PCN/19/013/C+N-US

Product range: Han D

Title: Han D female contact

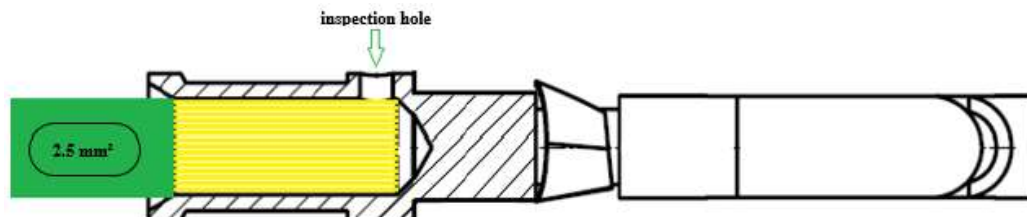
As a result of an improvement to the production process, the inspection hole location on the part numbers above has changed to the picture below
